**LEXINGTON-FAYETTE URBAN COUNTY GOVERNMENT
CONTRACT CHANGE ORDER**

Date:	November 30, 2015	
Project:	Public Safety Operations Center Phase 1B Renovation	
Location:	115 Cisco Road	
Contract No.	287-2014	
Original Contract Amt.	\$6,109,000.00	
Cumulative Amount of Previous Change Orders	\$316,145.73	
Percent Change - Previous Change Orders		5.18%
Total Contract Amount Prior to this Change Order	\$6,425,145.73	
Change Order No.	9

Re: Proposal Review
MGT PR 30 – Plumbing change Unisex 145B, IDF 145A, Shift Supervisor 147 and
Dispatch 146A.
Emergency Operations Center Phase 1B
Lexington Fayette Urban County Government
Lexington, Kentucky
Marcum No. 13618

SUBJECT: RFP 4 – Plumbing Modification Unisex 145B, IDF 145A, Shift Supervisor 147, and 911 Dispatch 146A.

SHEET
XP04

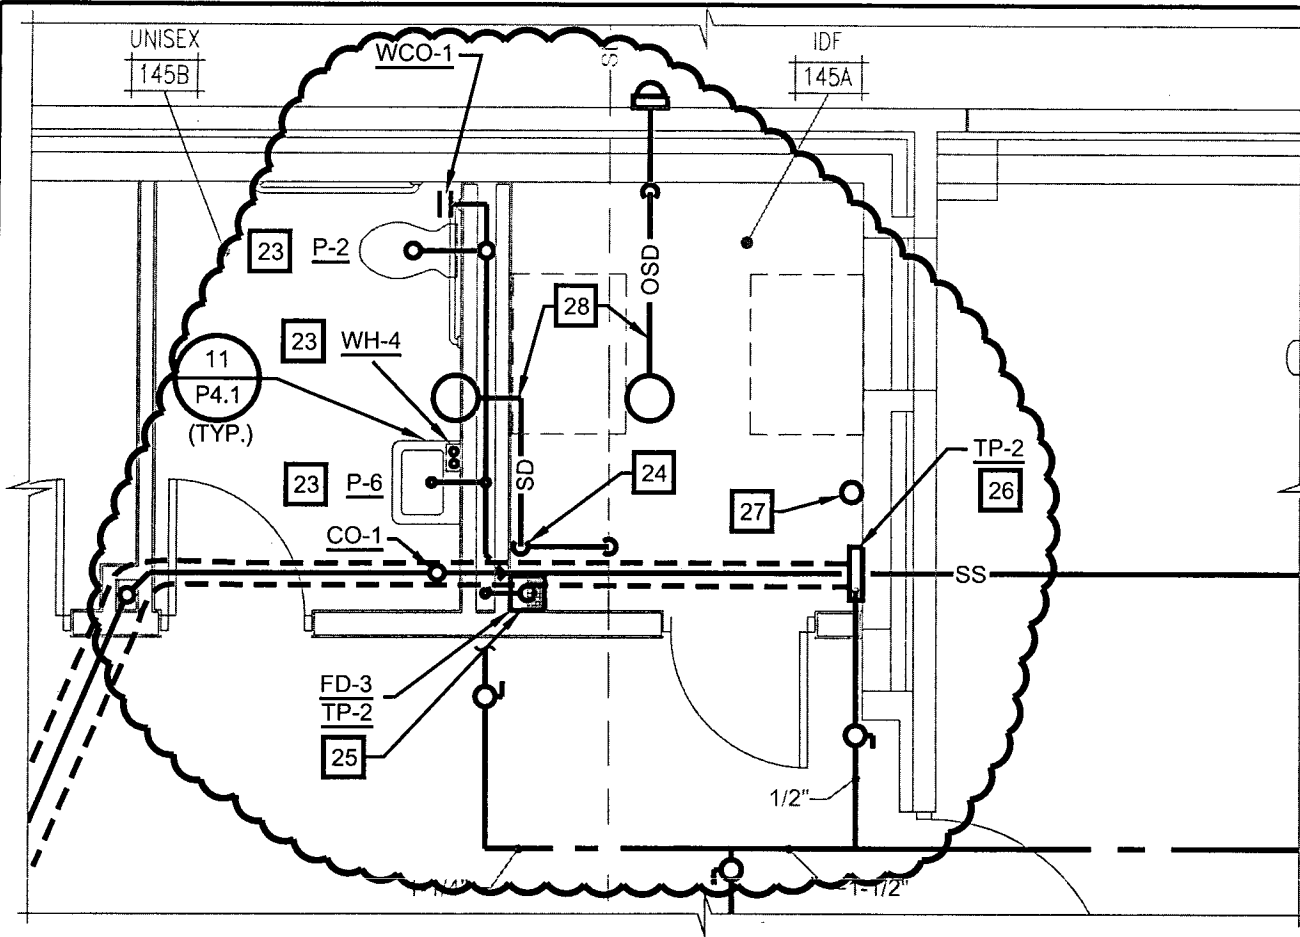
The Contractor shall modify the storm drain piping, overflow piping, sanitary drains and vents, trap primer piping and domestic water piping as depicted in Sketches XP04 and XP05 to accommodate the revised floor plan.

The Contractor shall provide a proposal to furnish and install (1) additional FD-3 floor sink as shown on Sketch XP04. Floor sink shall be installed under raised floor and 1" above concrete slab below.

23	ROUGH-IN PLUMBING FOR FUTURE P-2, WH-4, AND P-6 AT FUTURE RAISED FLOOR HEIGHT (APPROXIMATELY 20"). REFER TO ARCHITECTURAL DRAWINGS.
24	LOCATE STORM DRAIN TO DROP ALONG WALL IN IDF ROOM. CONNECT TO EXISTING UNDERSLAB MAIN BY SAWCUTTING AND PATCHING EXISTING CONCRETE FLOOR.
25	LOCATE FLOOR DRAIN IN EXISTING FLOOR SLAB WITH 1" RAISED RIM. DRAIN WILL BE BENEATH FUTURE ACCESS FLOORING.
26	LOCATE AS SHOWN WITH BACK OF UNIT 1 1/4" OFF OF EXISTING PRE-CAST WALL TO ALLOW FOR HAT CHANNEL AND SHEET ROCK. COORDINATE WITH ARCHITECTURAL WALL DETAIL.
27	WALL MOUNTED CHEMICAL FIRE SUPPRESSION TANK LOCATION.
28	ROUTE HORIZONTAL DRAIN LINES TIGHT AGAINST CONCRETE ROOF STRUCTURE TO ALLOW FUTURE CEILING OF 8'-6" AFF.

SHEET
XP05

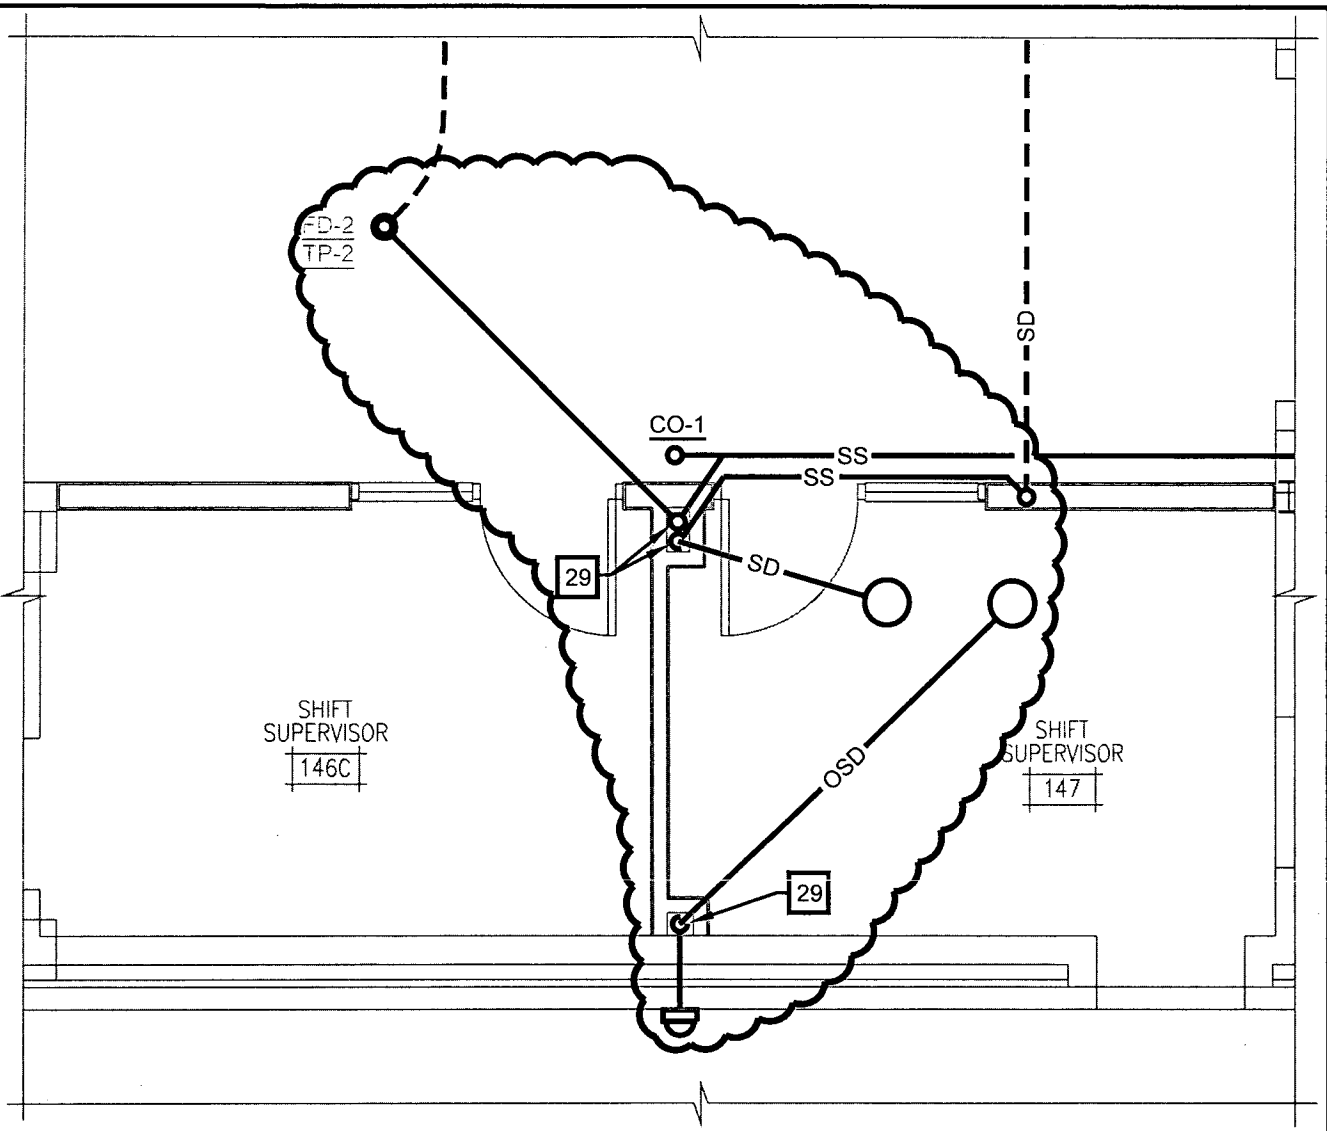
29	LOCATE VERTICAL PIPING AT FUTURE CHASE LOCATION.
----	--
